9/13/96	Class B Concrete changed to Class A.
6/14/96	Notes added to clarify plans.
DATE	REVISION
STATE OF HAWAII DEPARTMENT OF TRANSPORTATION HIGHWAYS DIVISION	
DRAINAGE PLAN	
KALANIANA'OLE HIGHWAY RESURFACING	
Kailua Rd. to Hilo St.	
Project No. 72A-01-96M	
Scale: 1"=40'	Date: May 1996
SHEET No. 44 OF 44 SHEETS

KALANIANA'OLE HIGHWAY RESURFACING

Project No. 72A-01-96M

DATE	REVISION
STATE OF HAWAII DEPARTMENT OF TRANSPORTATION HIGHWAYS DIVISION DRAINAGE PLAN KALANIANA'OLE HIGHWAY RESURFACING Kailua Rd. to Hilo St. Project No. 72A-01-96M Scale: 1"=40' Date: May 1996

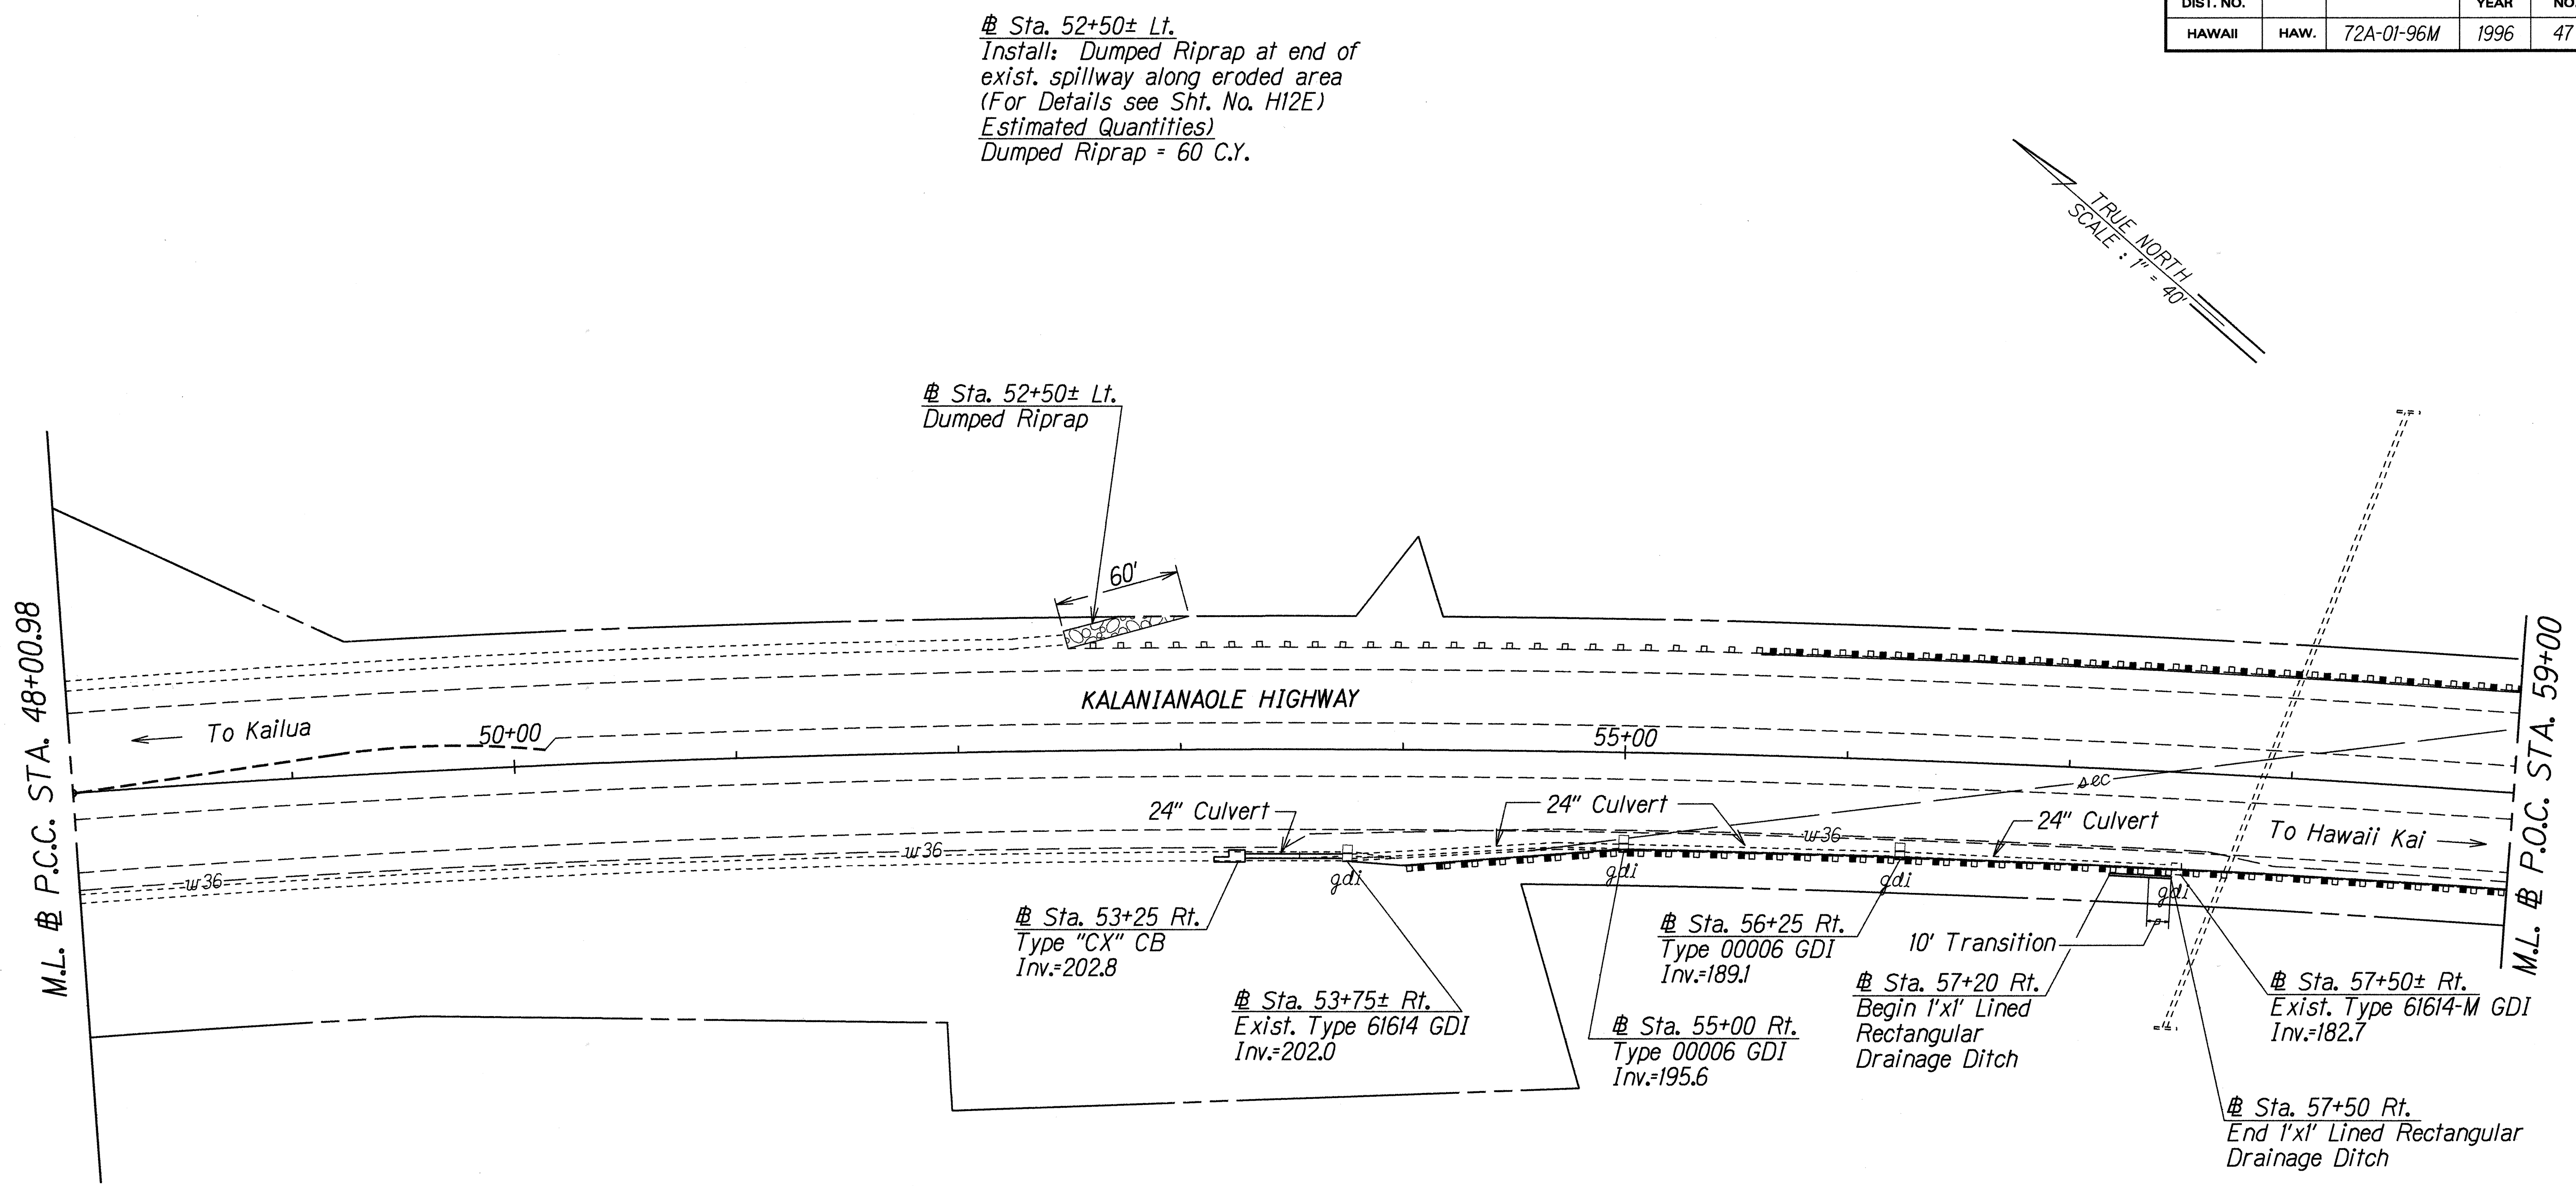
12/5/96	Changed beginning of 1'x1' Lined Rectangular Drainage Ditch
10/1/96	Notes revised to clarify plans.
9/13/96	Changed Type 61214B GDI to Type "CX" CB and portion of Type 2D Curb replaced with 1'x1' Lined Rectangular Drainage Ditch.
6/14/96	Notes added to clarify plans.

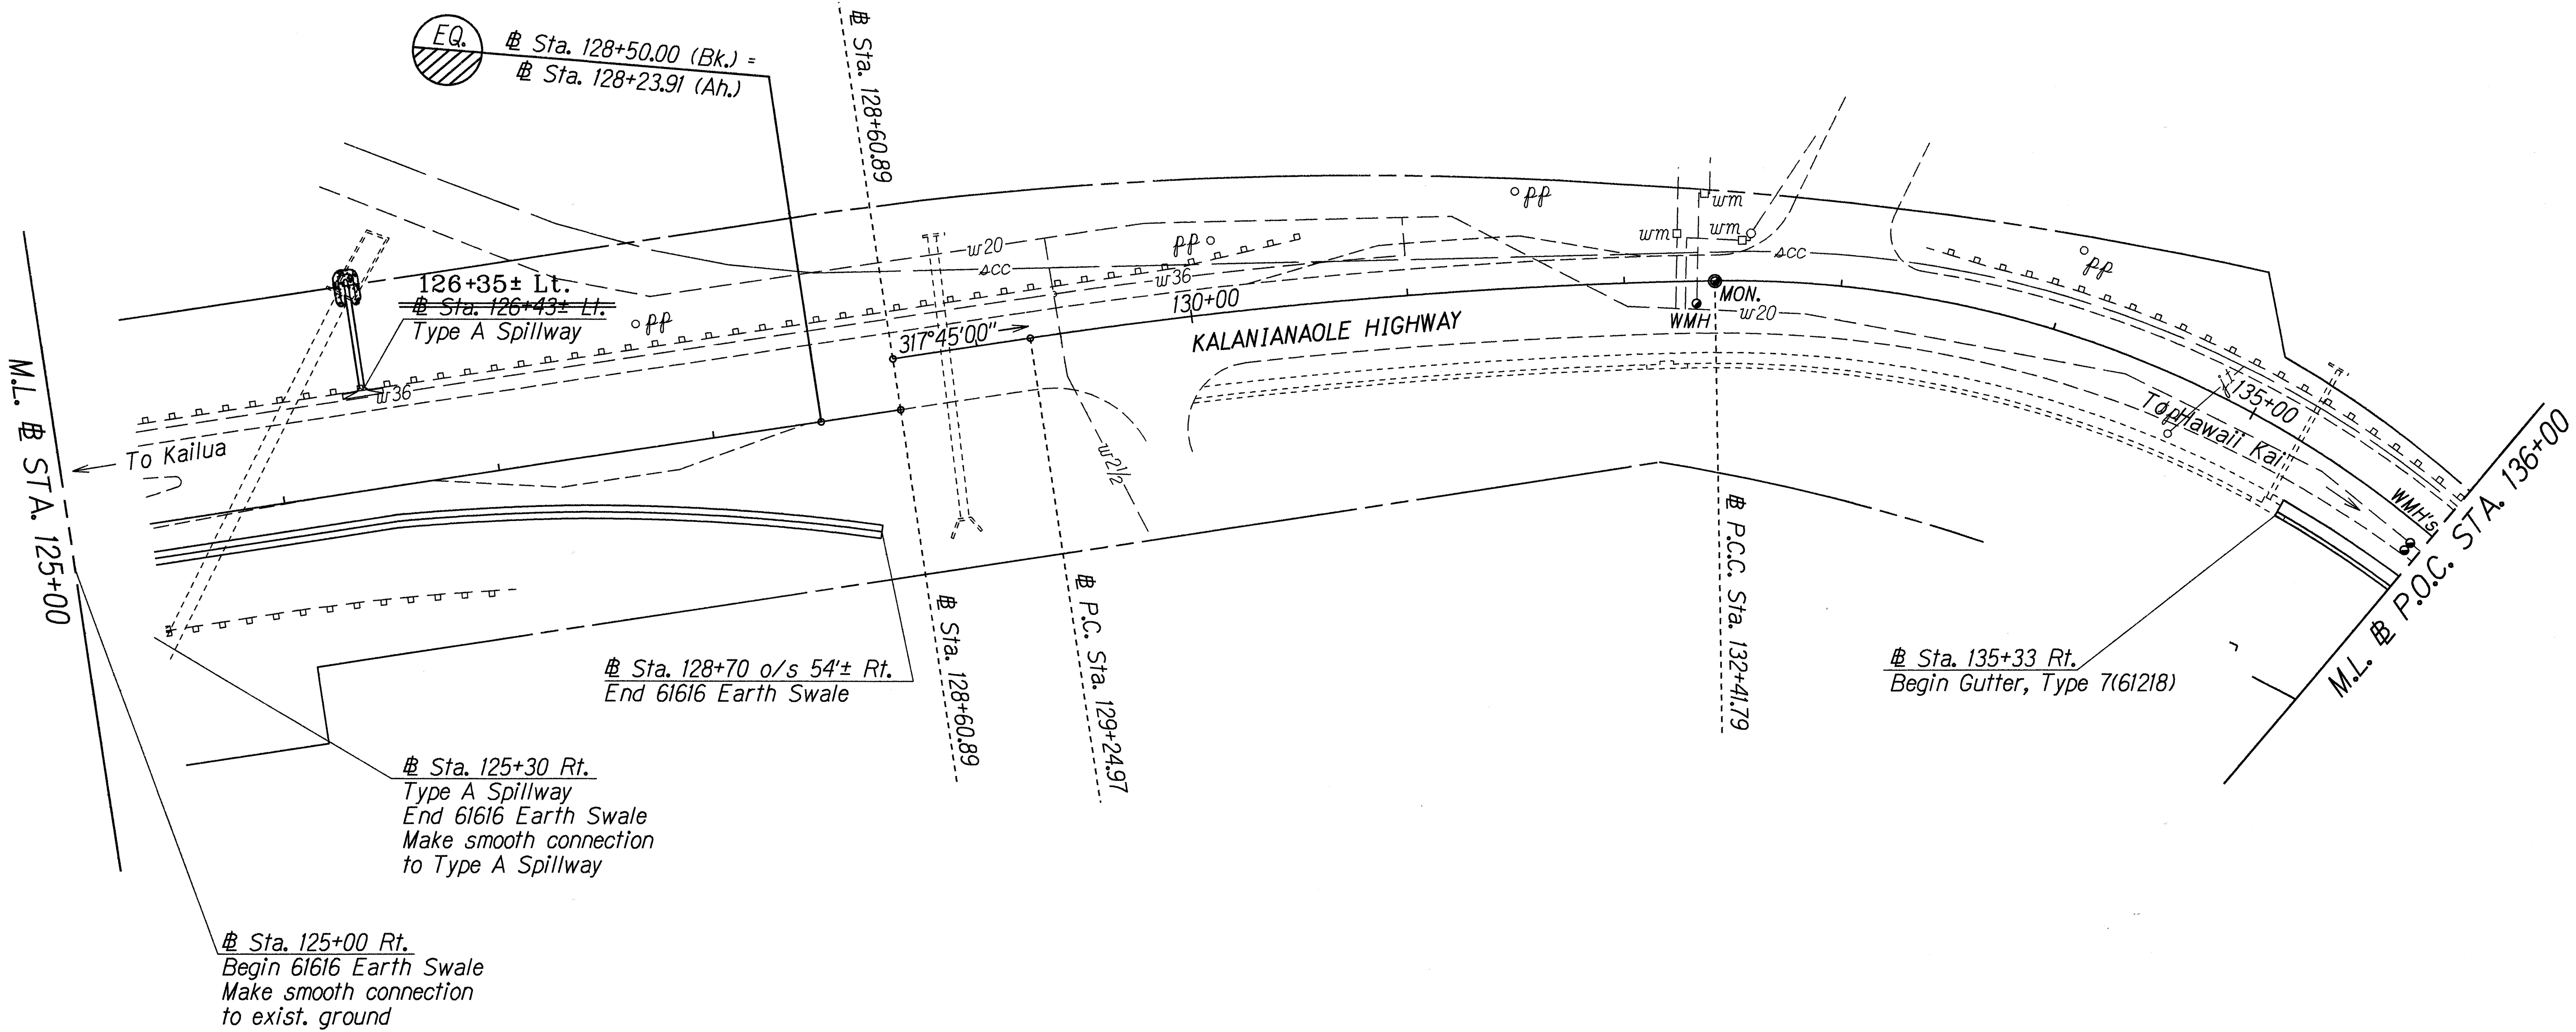
12/5/96	Added spillway at # Sta. 126+43± Rt.
6/14/96	Notes added to clarify plans.
DATE	REVISION
STATE OF HAWAII DEPARTMENT OF TRANSPORTATION HIGHWAYS DIVISION	
DRAINAGE PLAN	
KALANIANA'OLE HIGHWAY RESURFACING	
Kailua Rd. to Hilo St.	
Project No. 72A-01-96M	
Scale: 1"=40'	Date: May 1996
SHEET No. H11 OF 12 SHEETS

126+35± Lt.
~~# Sta. 126+43± Lt.~~
Construct: Type A Spillway,
2'x1' Concrete Lined Vee Ditch
(For Details see Sht. Nos. H12I & H12J)
Estimated Quantities
Ditch and Channel Excavation = 6 C.Y.
2'x1' Concrete Lined Vee Ditch = 44 L.F.
Type A Spillway = 1 Ea.
Dumped Riprap = 4 C.Y.

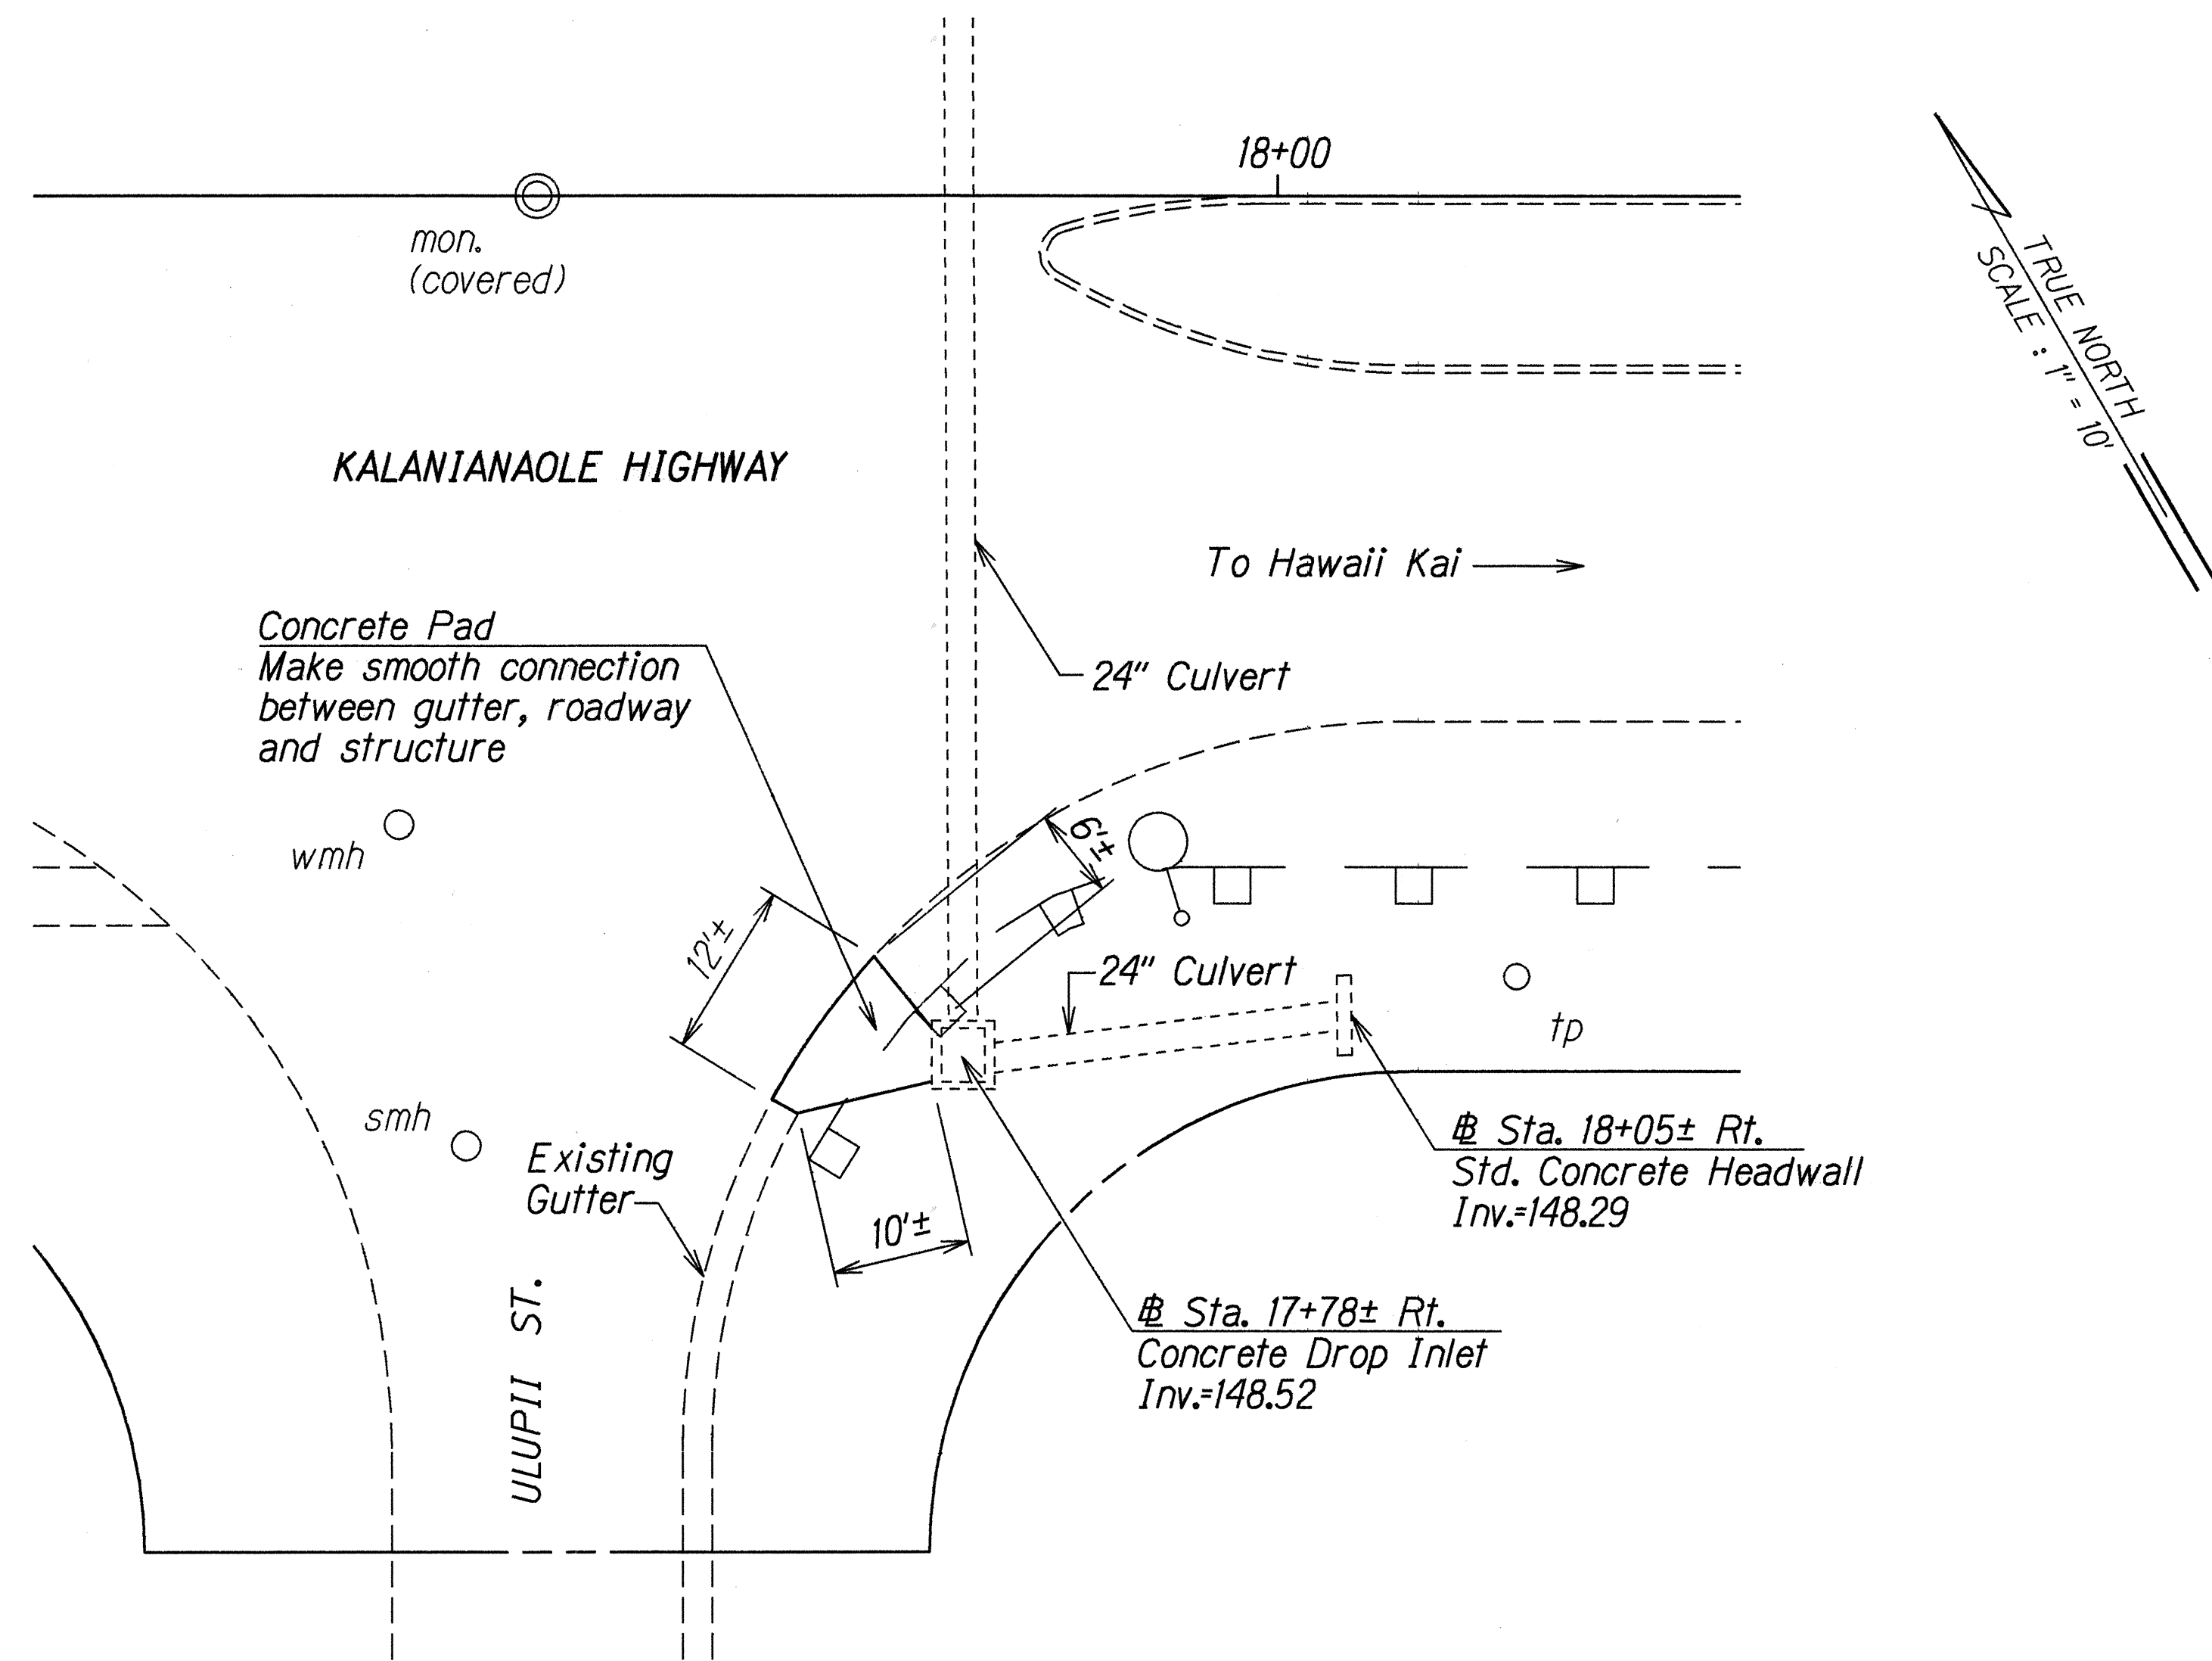
9/13/96	Class B Concrete changed to Class A.
6/14/96	Details added to complete drainage plan.
DATE	REVISION
STATE OF HAWAII DEPARTMENT OF TRANSPORTATION HIGHWAYS DIVISION	
DRAINAGE DETAILS	
KALANIANAʻOLE HIGHWAY RESURFACING	
Kailua Rd. to Hilo St.	
Project No. 72A-01-96M	
Scale: As Noted	Date: June, 1996
SHEET No. H12A OF 12 SHEETS
